LiDAR Quality Assessment Report

WA_MtBaker_2015

NGTOC
2016-05-25
Brent Marz

Checkpoint Distribution Image

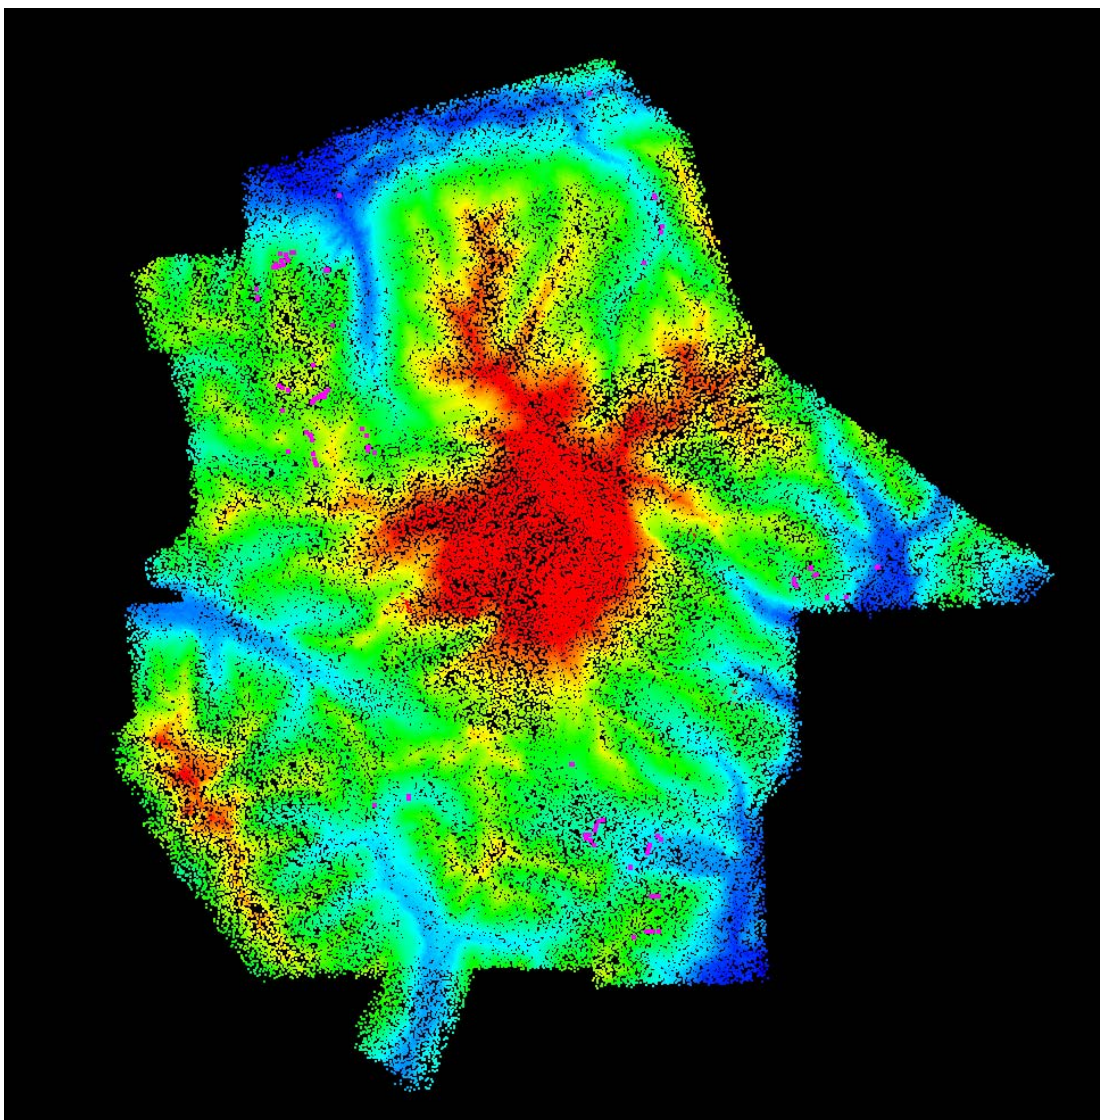
Reports do not specify if vertical accuracy was ran on raw swath or DEMs, both tests are required.

Fixed 5/23
